APPLICATION NO.	FILING DATE	FIRST NAMED INVENTOR	ATTORNEY DOCKET NO.	CONFIRMATION NO.
10/701,883	11/05/2003	Nabil L. Muhanna	49272.830034.US2	6707
70818 7590 10/08/2010 Holland & Hart, LLP (LANX, Inc.) Intellectual Property Department P.O. Box 8749 Denver, CO 80201-8749				
EXAMINER				
PRONE, CHRISTOPHER D				
ART UNIT		PAPER NUMBER		
3738				
MAIL DATE		DELIVERY MODE		
10/08/2010		PAPER

Office Action Summary

DETAILED ACTION

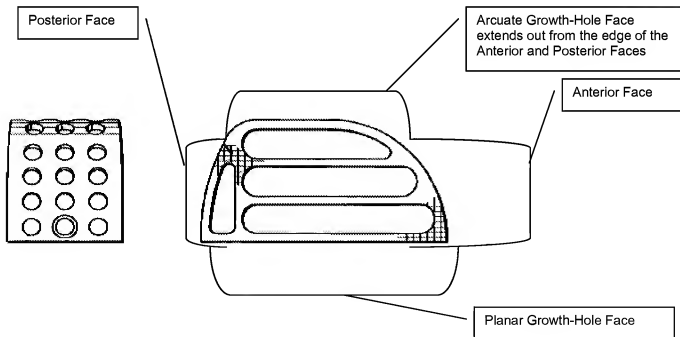
Michelson discloses a metal vertebral body replacement comprising a body 300, nonparallel top and bottom surfaces (shown best in figures 15-17) having a plurality of through holes and continuous grooves 314 and protrusions (5:62-65), two growth hole faces 310 (planar) and 312 (curved) having 4 through holes 319 and a curves anterior face 304. Michelson further discloses use of a second identical implant for insertion along side the first 300".

In response to the amended language a marked up figure is included below to demonstrate how the arcuate growth-hole face extends outward.

Applicant's arguments filed 12/23/09 have been fully considered but they are not persuasive. The applicant argues that Michelson fails to disclose an arcuate growth-hole face extending outward. This is not persuasive and has been addressed in the figure included above. The applicant further argues that Michelson fails to disclose serrations and at least one elongated groove in the top of the body that extends through the anterior face and the posterior face of the body in which teeth forming the serrations providing openings generally orthogonal to the at least one elongated groove. This is not persuasive because the combination relies on the teachings of Brantigan disclosing the use of grooves that extend through the anterior and posterior faces and Viart disclosing making the serrations out of a plurality of separate teeth to

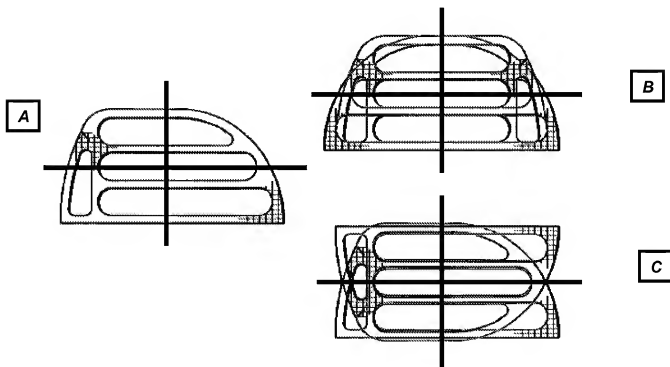
read on this claim language. The applicant further argues that implant is not asymmetrical when viewed from above. The following figure is included to show that the implant of Michelson is asymmetrical when viewed from the top. Figure A is the original top view of the implant. Figure B includes a top view of the implant that has been flipped horizontally and superimposed over the original top view. Figure C includes a top view of the implant that has been flipped vertically and superimposed over the original top view.
